Re: Application number 143227/JO/2025 rejection

Objection to Planning Application 143227/JO/2025 Didsbury Point, Manchester.

I live at 26 Clearwater Drive, where the rear boundary of my property adjoins the Didsbury Point development, and I am writing to register a formal objection to the Section 73 application for the variation of Condition 2 attached to the original planning permission 135235/FO/2022.

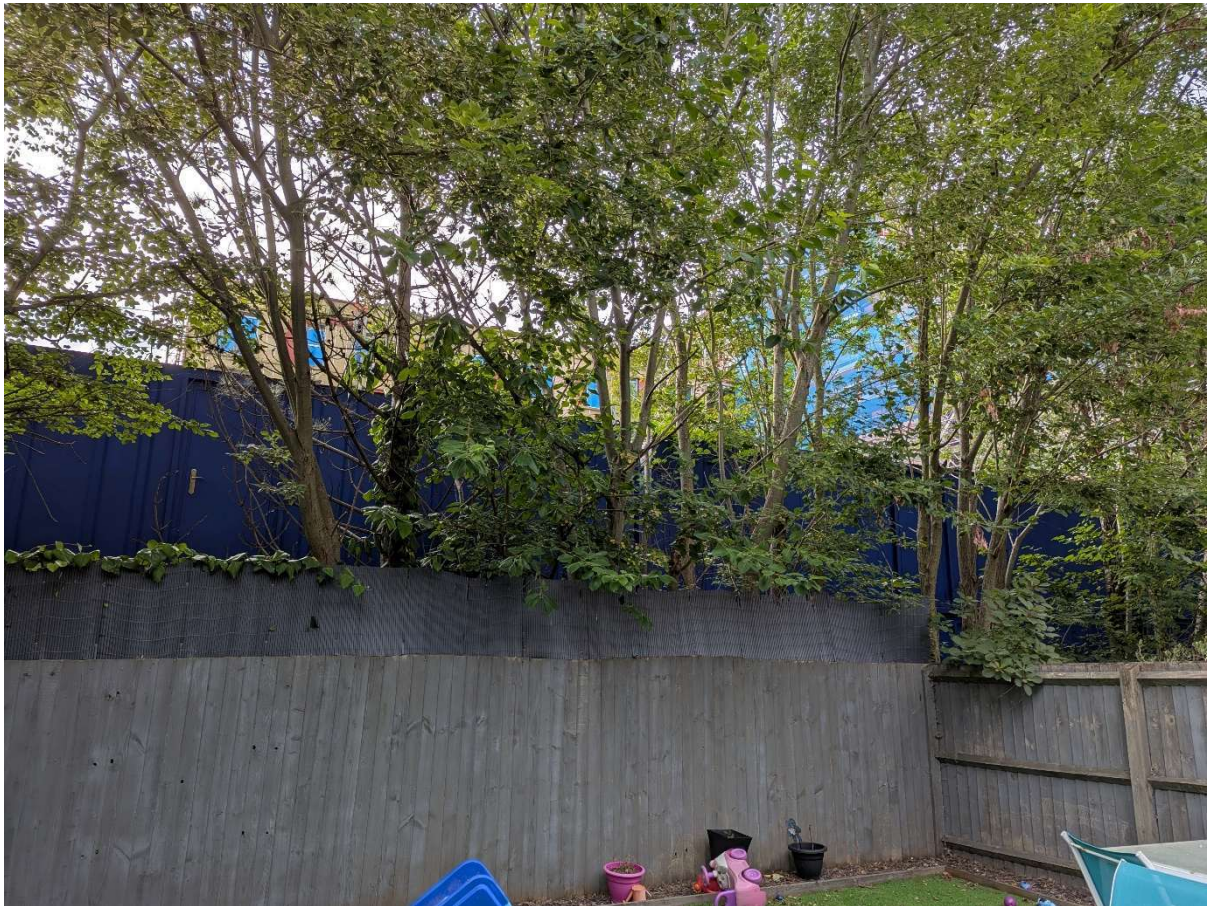
Below is a picture taken from my rear living room window showing the scale of the development in its current state. As can be seen, I have shipping containers towering over the rear fence, and this is the location of the green wall that was going to be built under the original application to approximately the same height.

These changes are neither minor nor technically necessary. In Item 4, the developer refers to the removal of the car park green wall, justifying it by noting that fire safety regulations for "living walls" are strict, and breaking the wall into smaller sections would be of "limited benefit."

This application suggests a lack of due diligence by the developer, which they included with the aim of inducing the approval of the original application—something they now intend to remove. A divided green wall is still vastly better than no green wall at all and would still soften the visual impact of a large, two-tiered car park podium.

The developer's claim that it is of "limited benefit" is subjective opinion, not fact. The visual benefit to me remains significant. Furthermore, the developer's promise of "additional areas of level planting" is vague and insufficient. A green wall serves a specific purpose: vertical greening to mitigate the impact of a large, unattractive facade. Ground-level planting elsewhere on the site will not achieve this and cannot, in any case, be enforced in terms of maintenance or even planting. Furthermore, the developer does not include specifics regarding the location of planting, its area, or how it can adequately compensate for the loss of a major visual mitigation feature of the car park. Crucially, the removal of the green wall represents a significant loss of a key mitigating feature of the original scheme.

Apart from the aesthetic aspect, the green wall would provide sound deadening to the car park, especially as the lower deck is an enclosed space. The sound of car doors will echo
